**J6801B-01****S E R V I C E                      N O T E**Supersedes:  
None**J6801B Distributed Network Analyzer**

Serial Numbers: SG46230615/ SG46241004

**Network Time Protocol synchronization does not function as clock-master correctly on affected units.****To Be Performed By: Agilent-Qualified Personnel****Parts Required:**

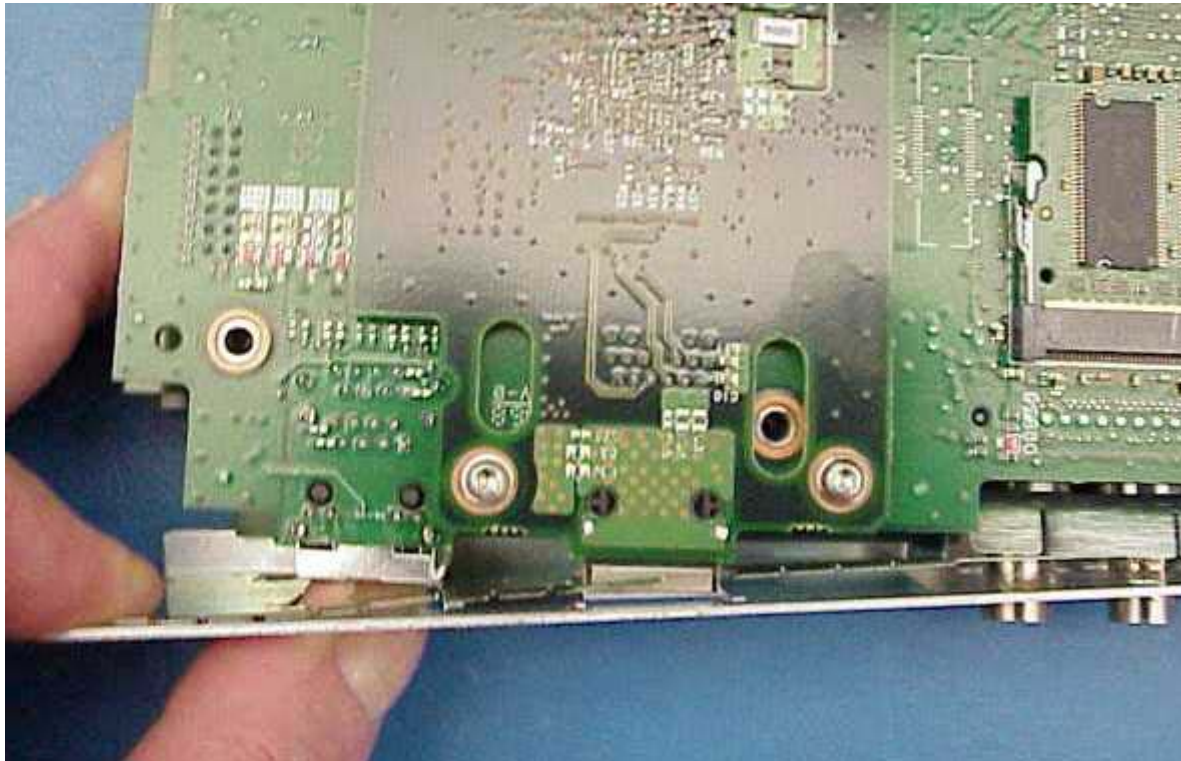
#2 Separate the board-stack at this connector.

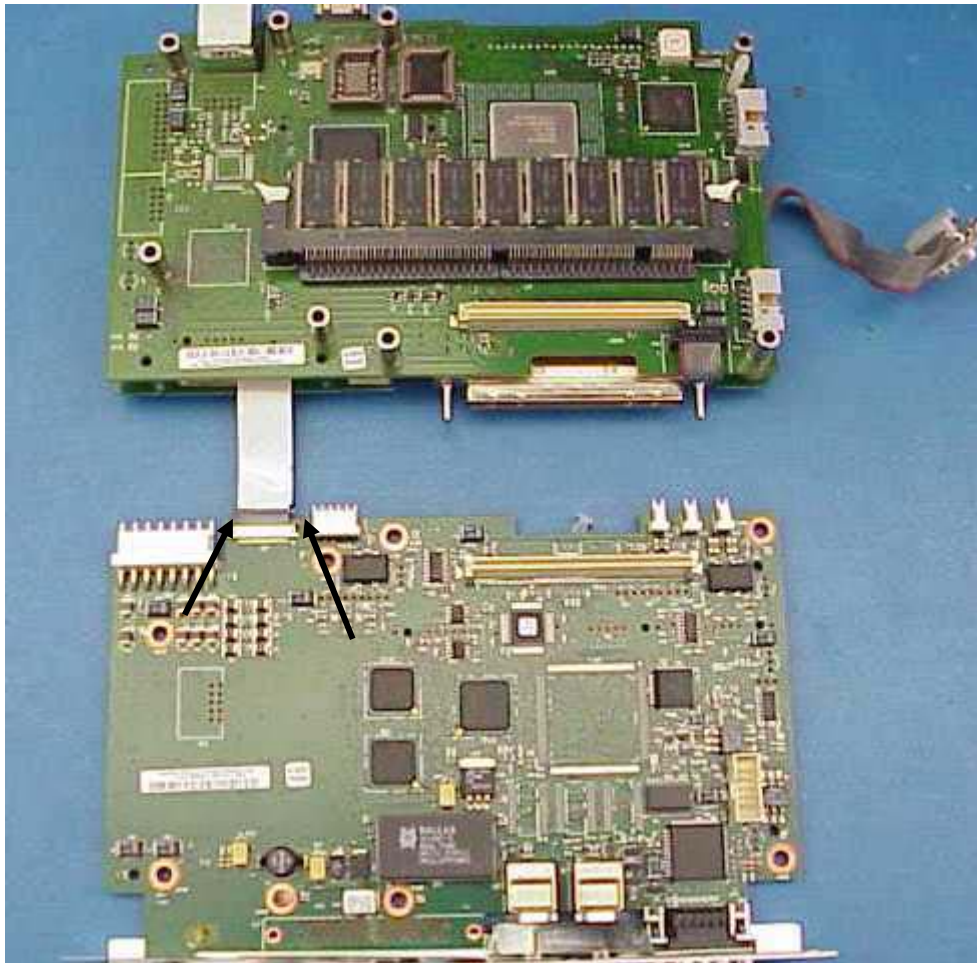
#4 Once the RJ connectors are clear of the sheet-metal rotate this top board away from you and place on the work surface. You should be presented with the view on the next page.

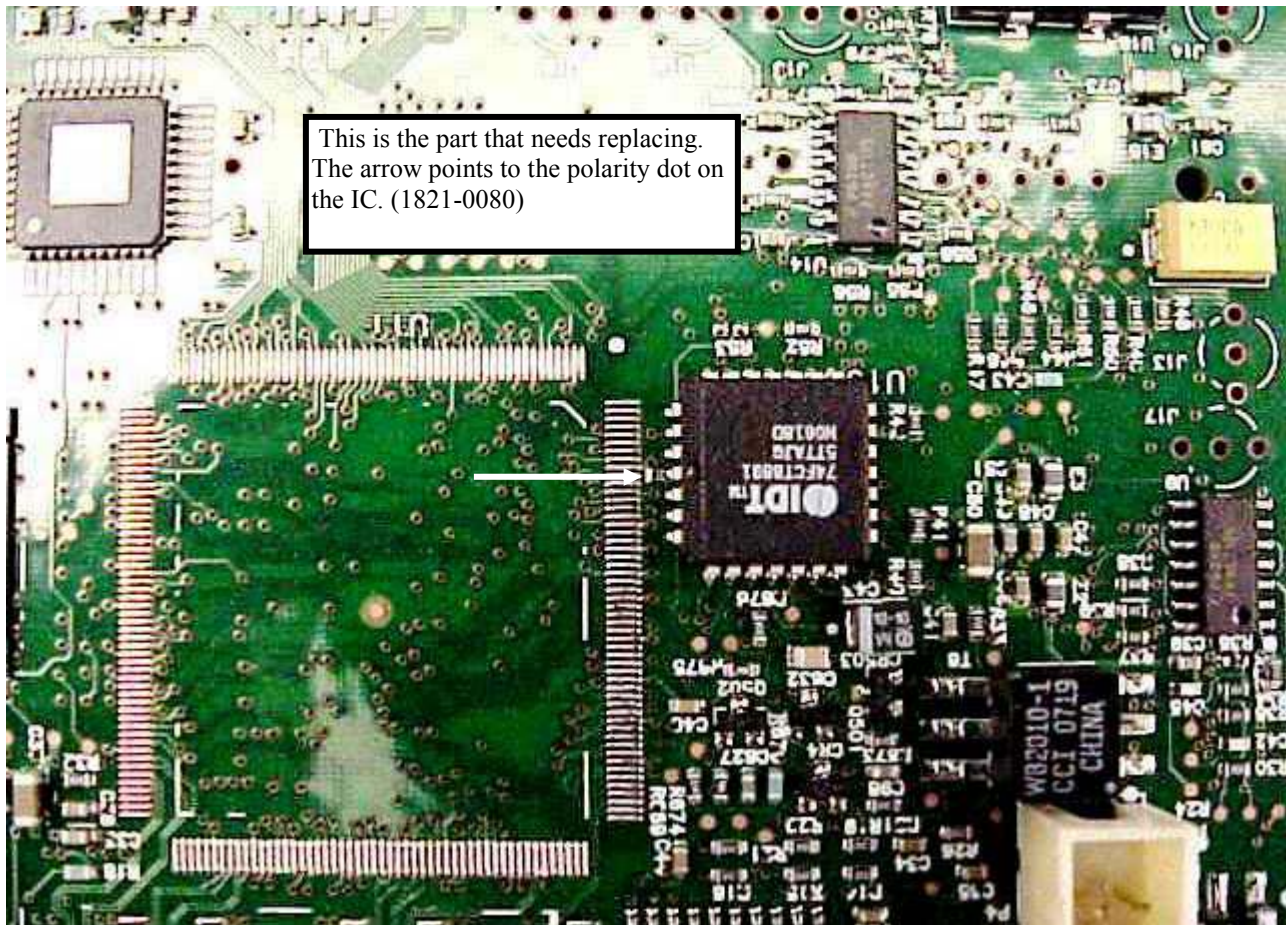
#5 Use caution when disconnecting the ribbon cable from the bottom board by gently pressing the tabs of the brown connector away from you. (See arrows)
